**Shaolin Tourist & Residential Development**  
**Comberton Grange, South Nowra, NSW**  
Response to Environmental Assessment Submissions  
MP06\_0135

December 2013

**RESPONSE TO ENVIRONMENTAL ASSESSMENT SUBMISSIONS  
& PREFERRED PROJECT REPORT****MP06\_0135: Tourist and Residential Development, Comberton  
Grange, South Nowra, NSW****1.0 INTRODUCTION**

Figure 8: Services infrastructure within pedestrian network – Northern portion of site

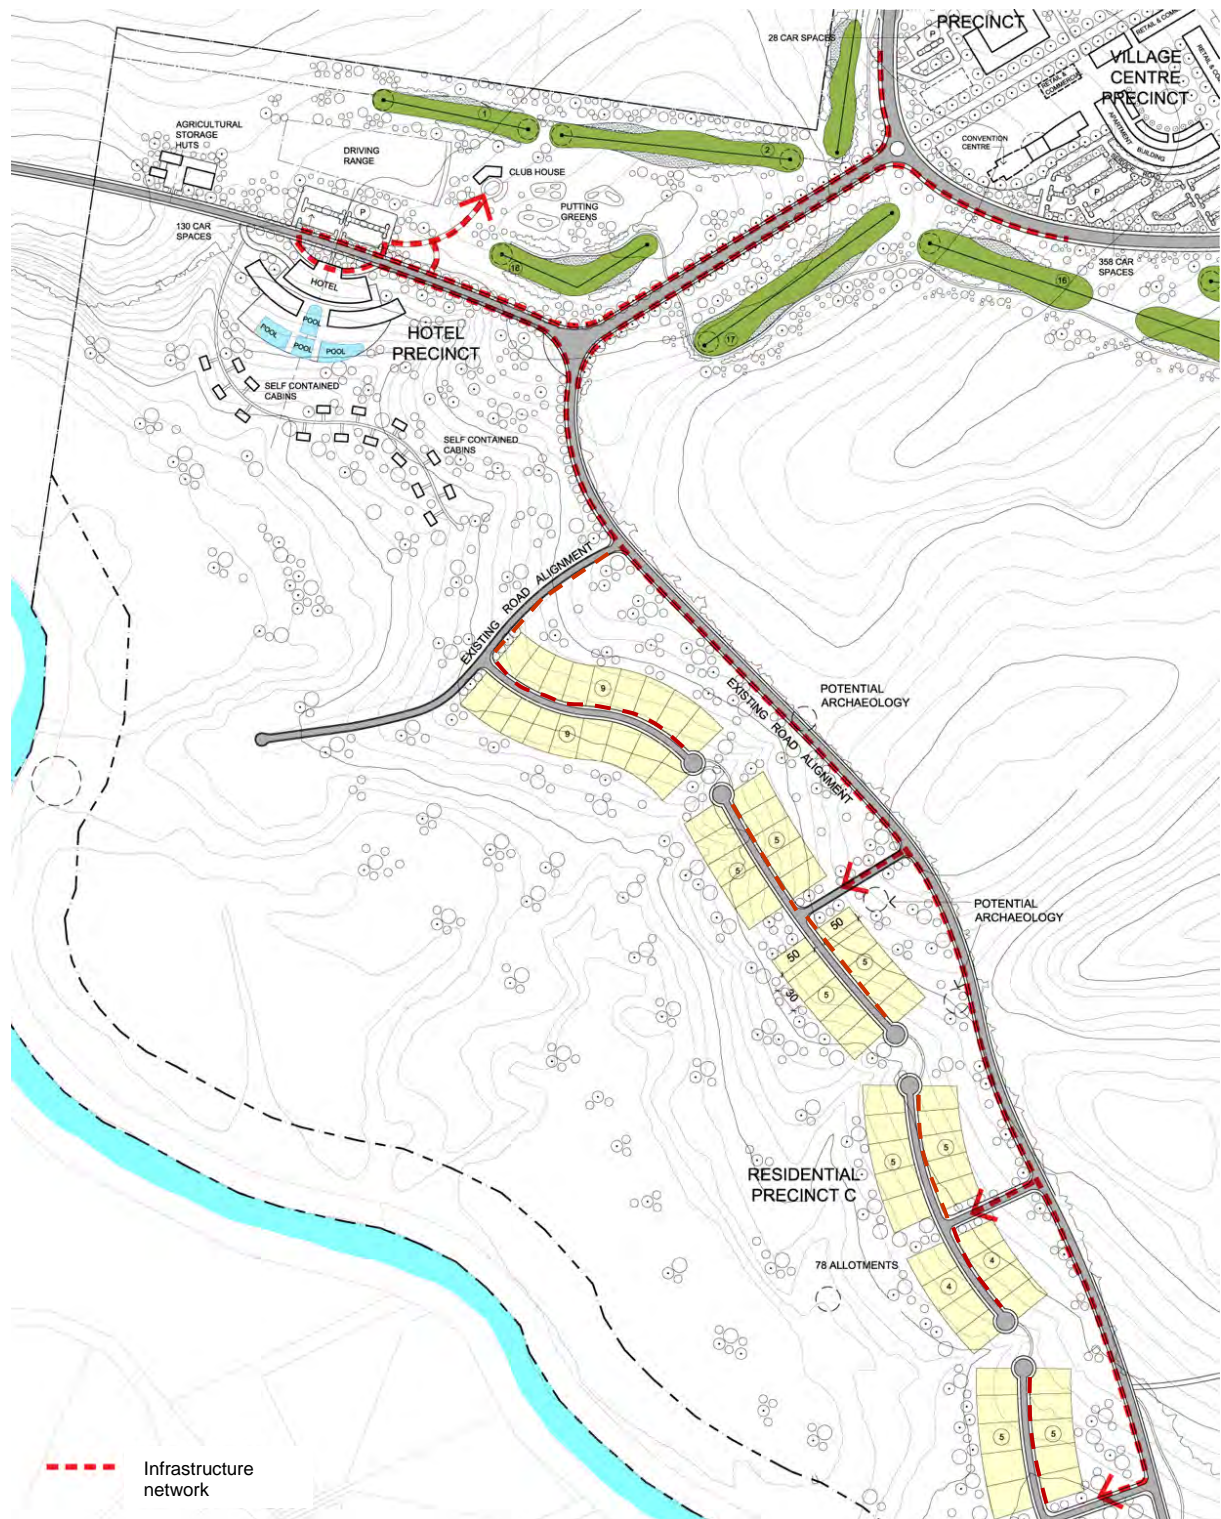
A plan showing the location of services and their connection points to existing services (i.e. within the road reserves) is to be provided.

Within the development area, all infrastructure services of water, sewerage, electrical, communications and gas will be located in the road reserves, within pedestrian footpaths. Internal infrastructure services will subsequently run along the road reserves of the new roadway to Forest Road and Comberton Grange Road to required connections to the east and west of the site. Detail of the layouts of these services will be submitted with future development applications for the development precincts.

A Concept Plan showing the location of services within the pedestrian network points is illustrated in:

Figure 11: Location of potential infrastructure connections to trunk mains from site

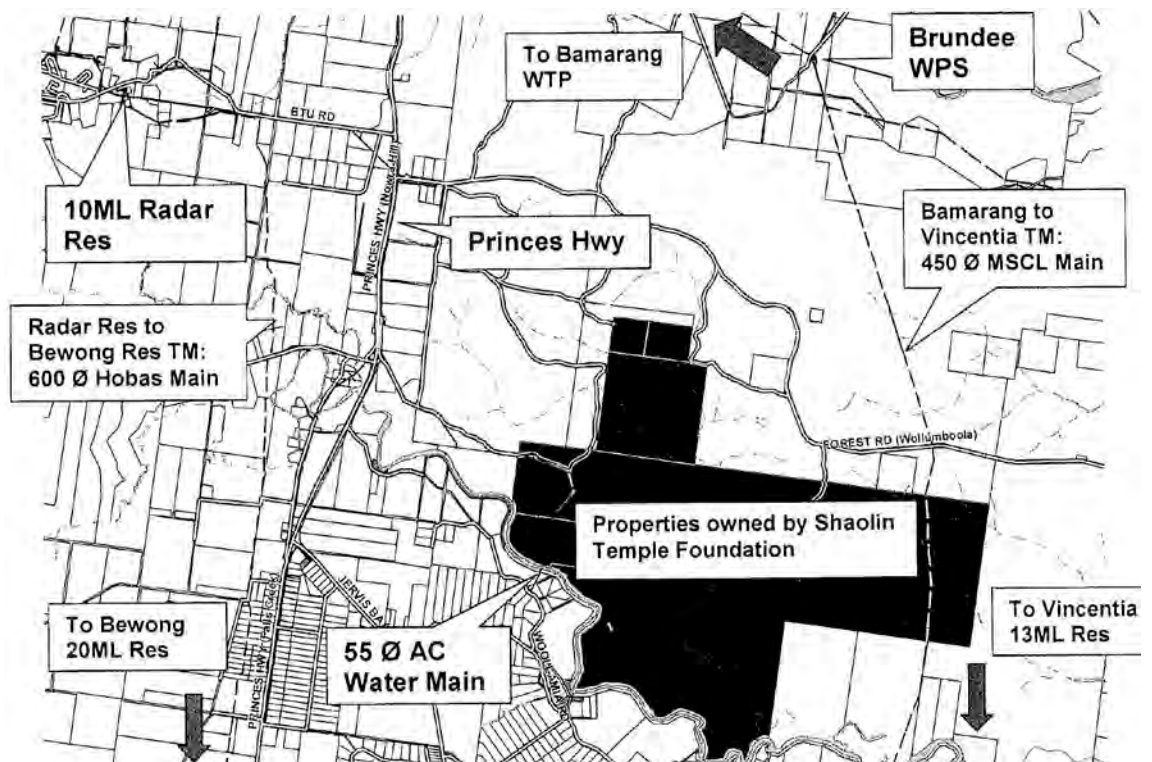
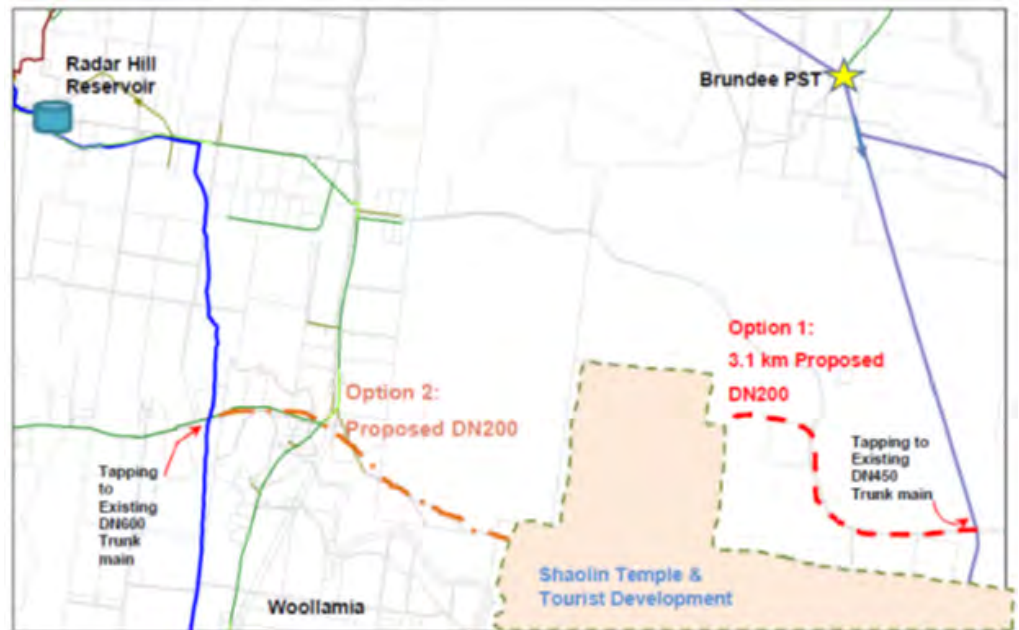
Further details are required (including evidence from service providers) regarding the certainty of the provision of infrastructure and services for the development. Revise the SoC to include such a commitment in the PPR.

Shoalhaven Water advised (on 13 June 2013) that in general, both options are hydraulically feasible.

The Brundee trunk main (being the Brundee-Vincentia supply system) is a 450mm diameter MSCL trunk main that traverses the eastern part of the site. The trunk water main can provide limited water supply by gravity means at low demand periods, and may require the construction of a local reservoir to supply adequate flow and pressure to the development. However, the capacity of Vincentia reservoir has been exceeded, based on the approximate demand loading under design peak day demand.

The Proponent is committed to provide infrastructure services to the site and will be undertaking further discussions with infrastructure providers of Shoalhaven Water and other State authorities to ensure that the site is supplied with the required infrastructure.

- Figure 13 (07062-MP12(B): *Bushfire APZ Map – North*;
- Figure 14 (07062-MP13(B): *Bushfire APZ Map – South*; and
- Figure 15 (07062-MP14(B): *Bushfire APZ Map 2 – South*.

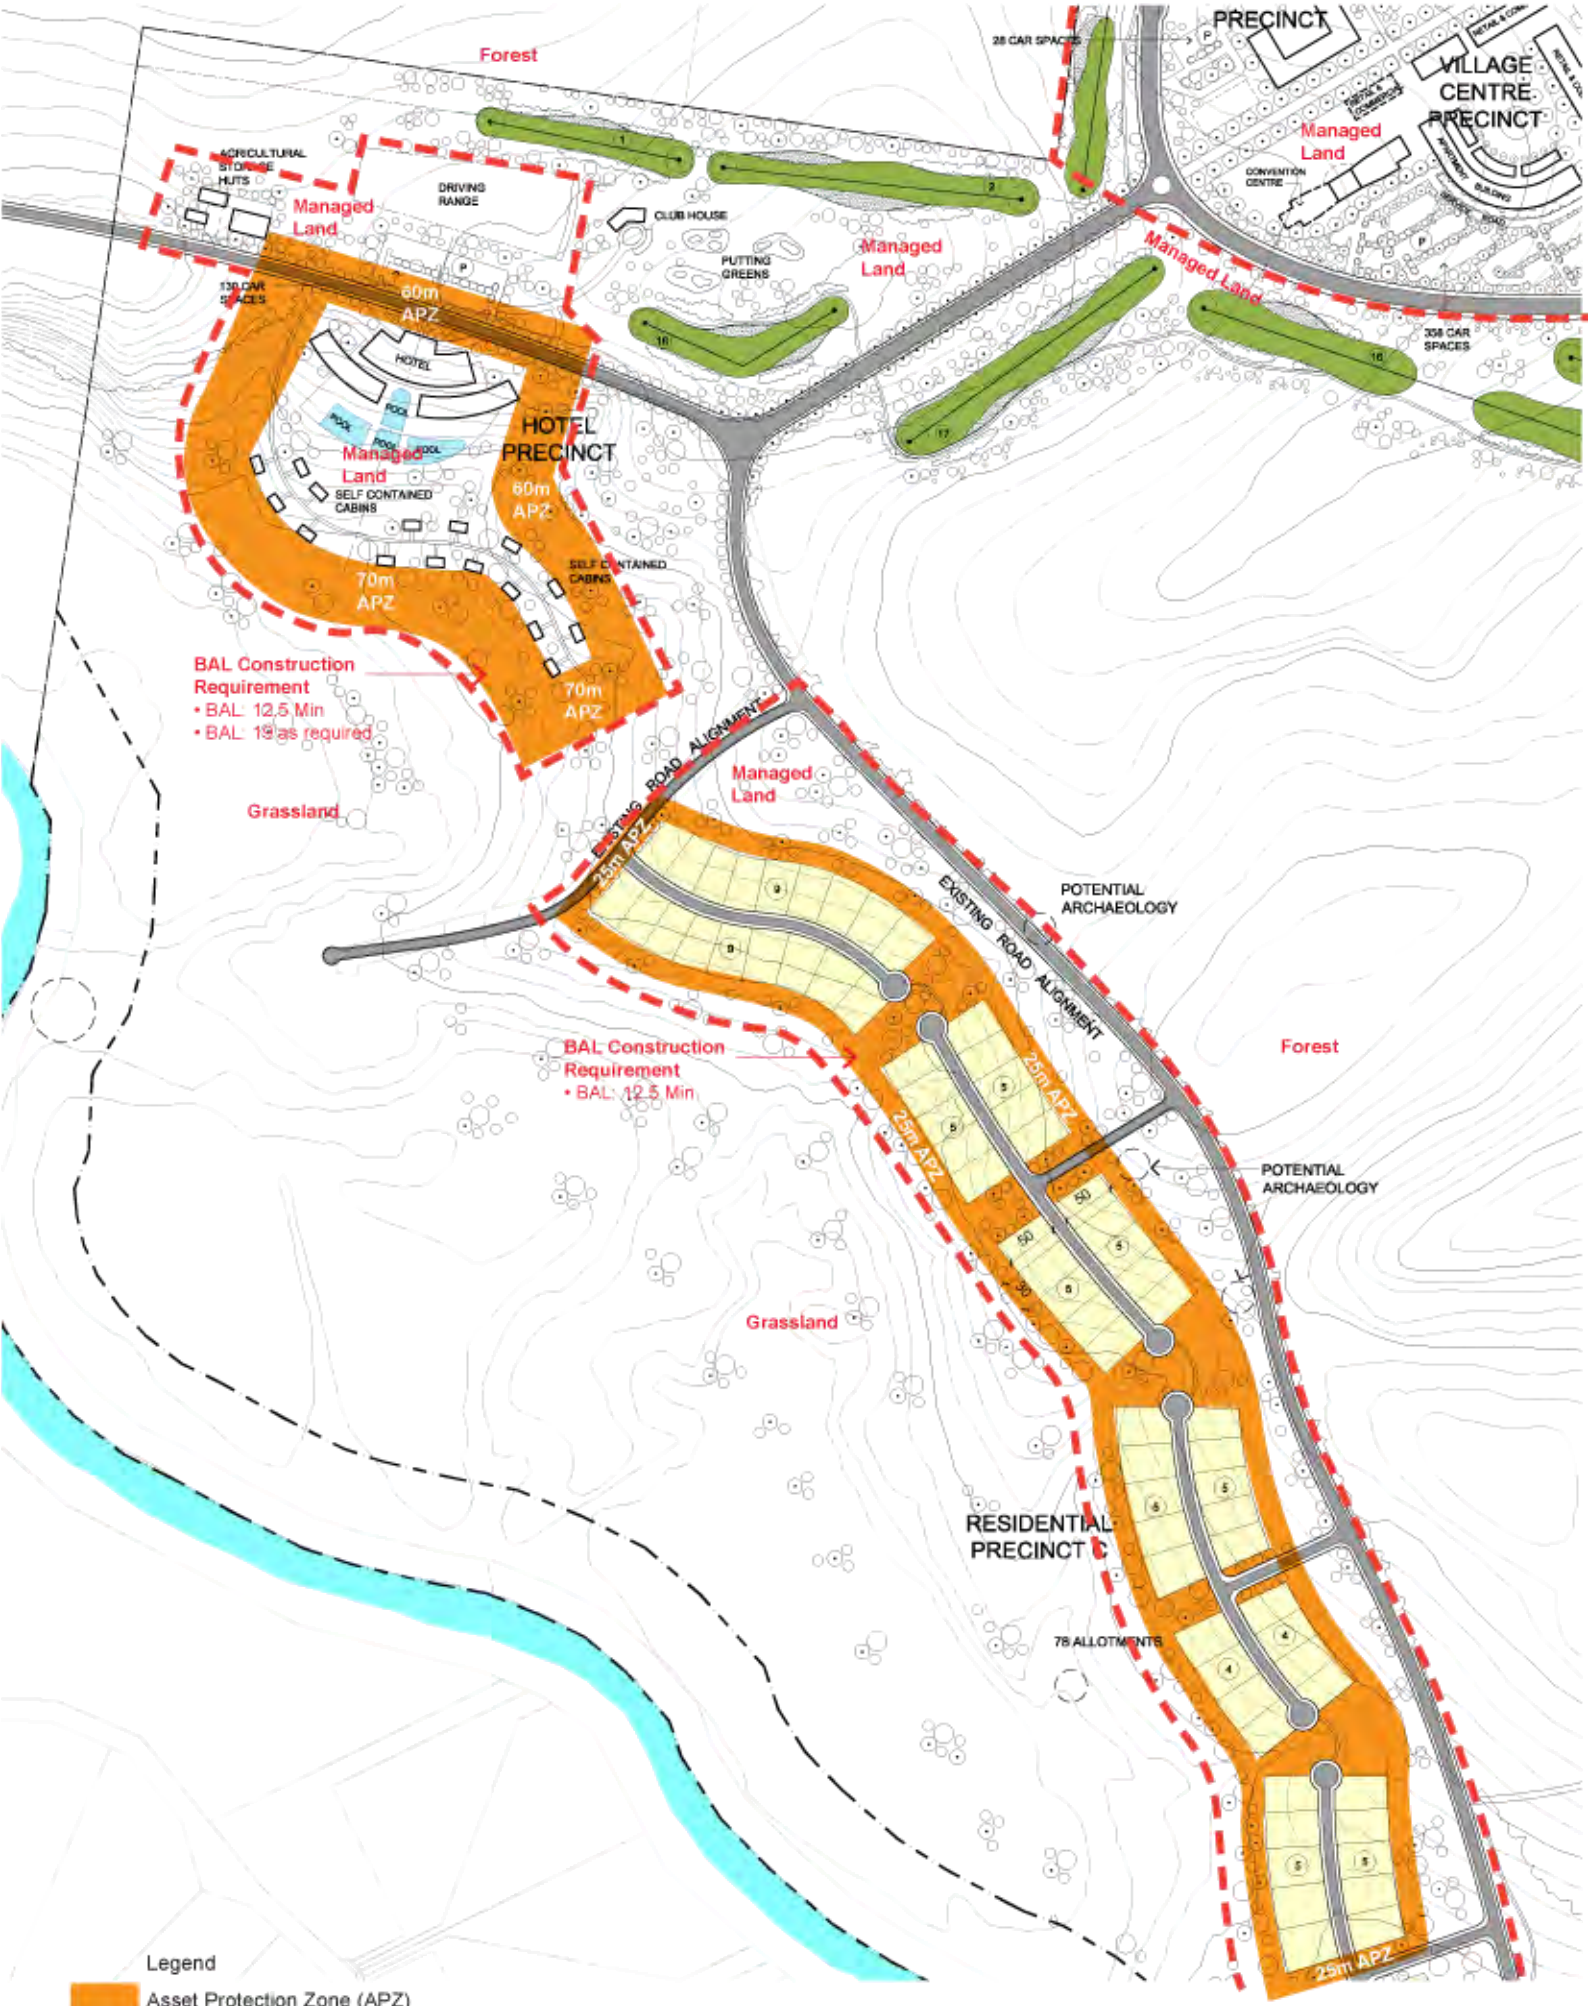
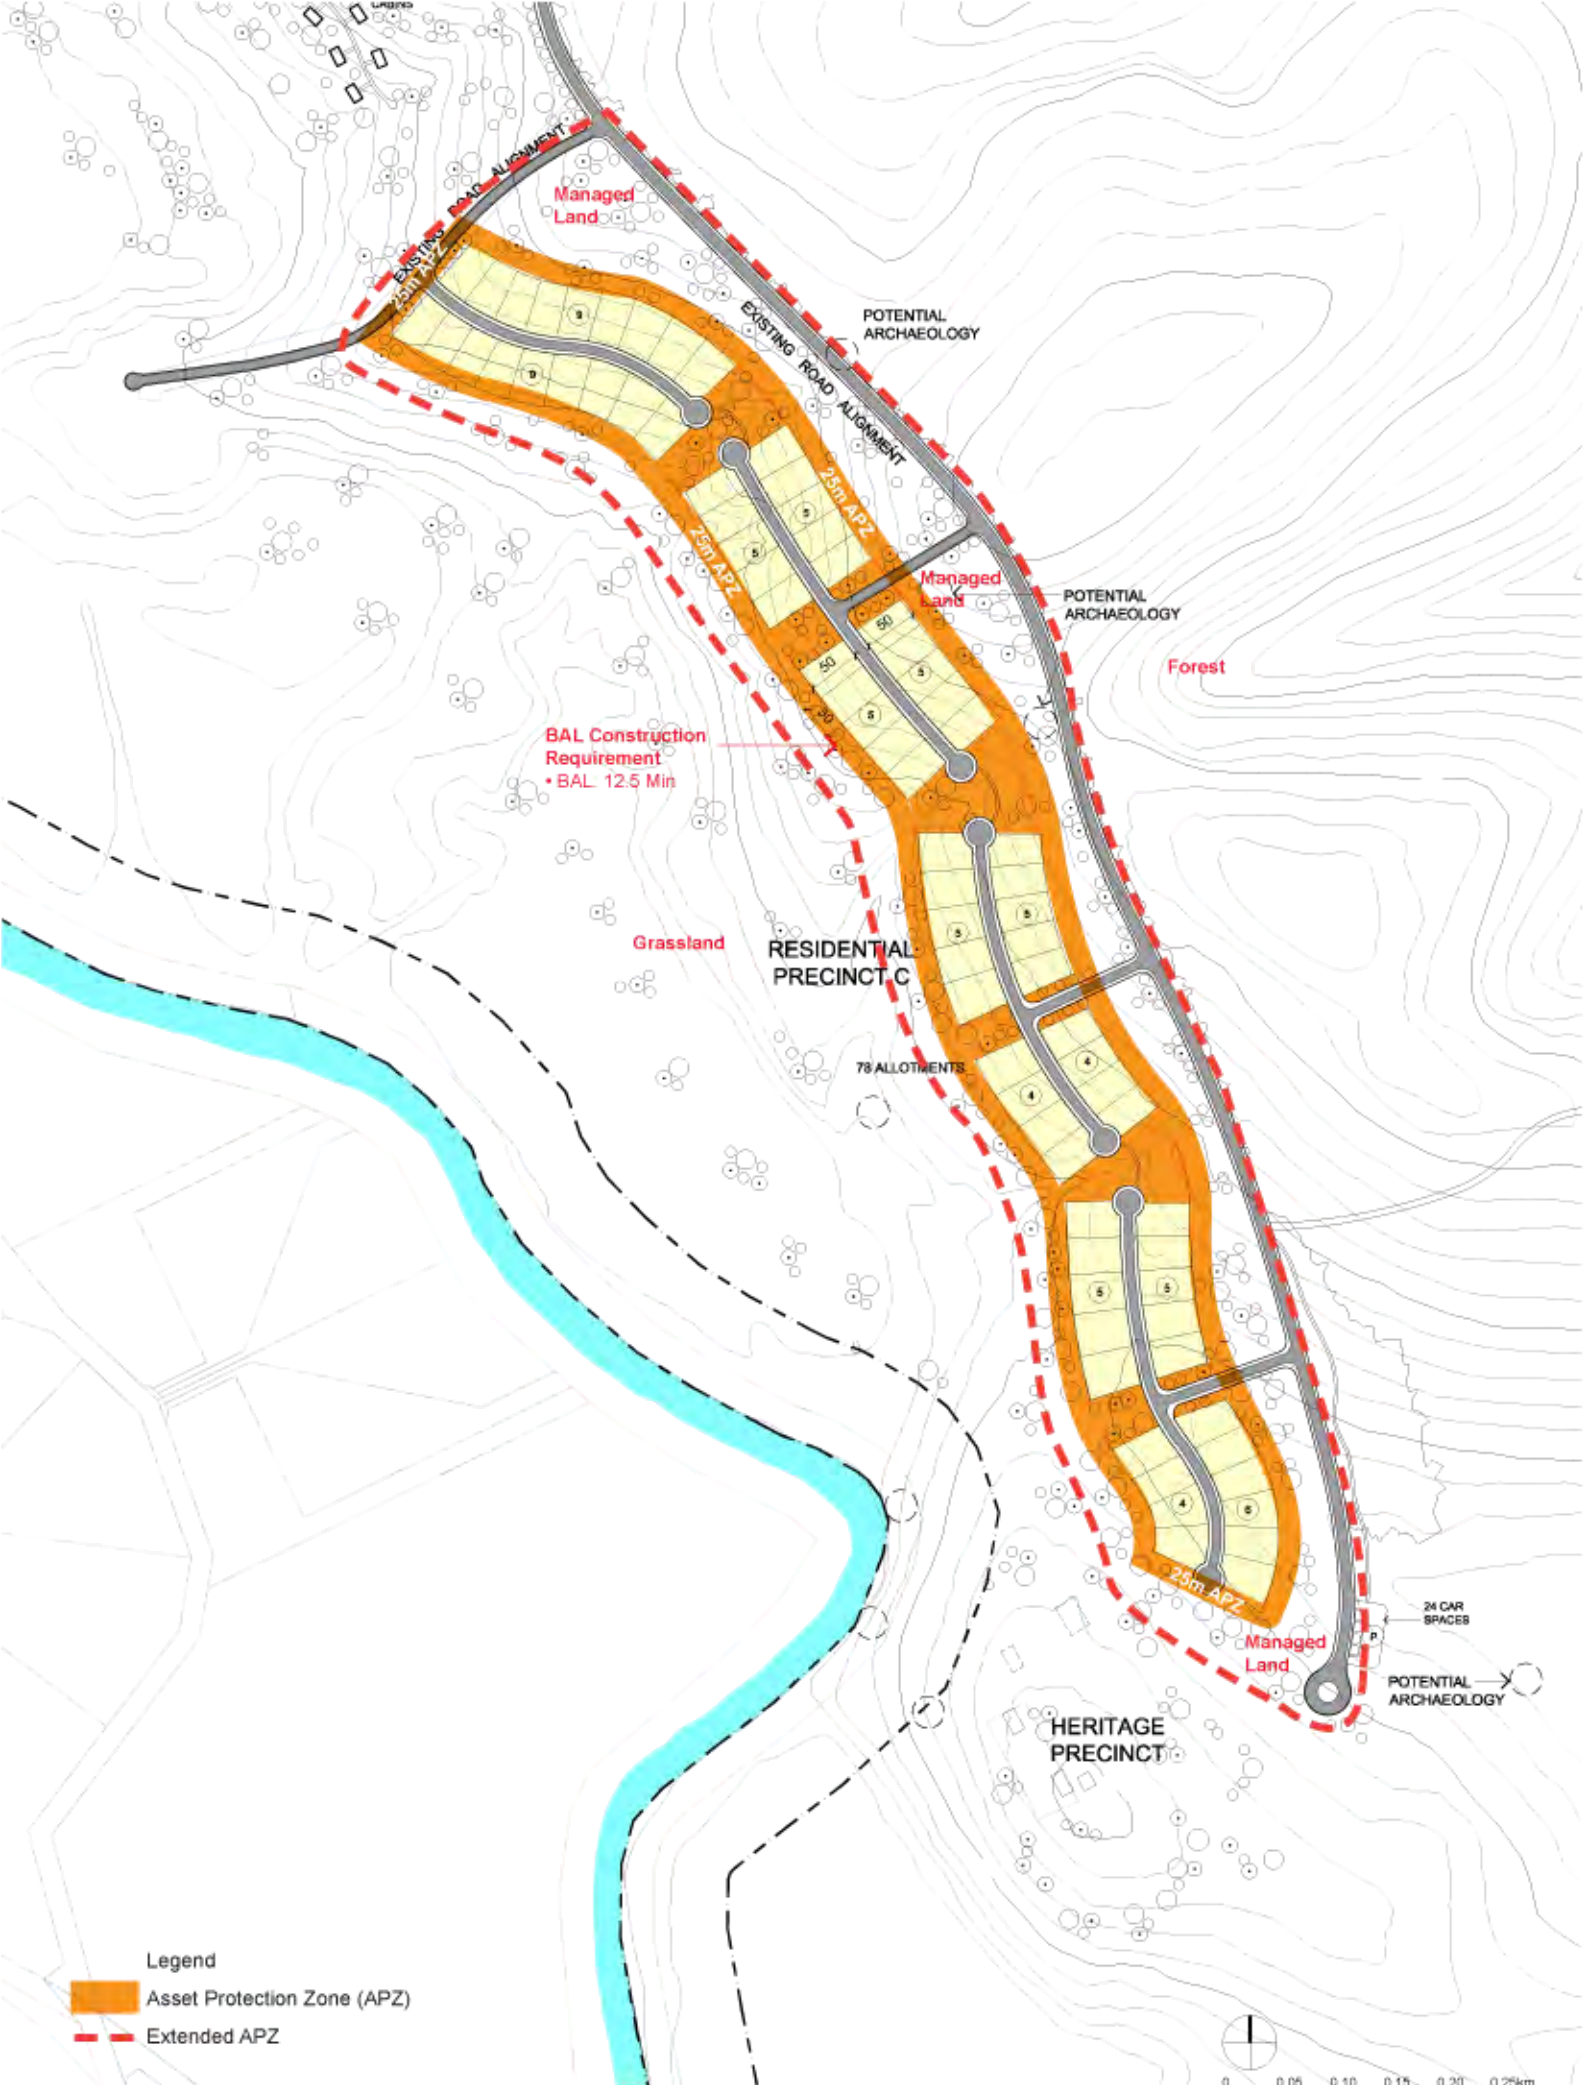
Asset Protection Zones (APZs) in accordance with PFBP need to be shown on the Concept Plan.

Fire trails will be provided around the perimeter of the northern development site, along the external boundary of the golf course encircling this portion of the site. Fire trails are to be minimum 3.5m wide and constructed to the required cross-falls. Refer to s.7.17.5 – *Fire Trail Design* in the EA Report.

Refer to Figures 13 (MP12(B)), 14 (MP13(B)) and 15 (MP14(B)) for Asset Protection Zones and Access Routes.
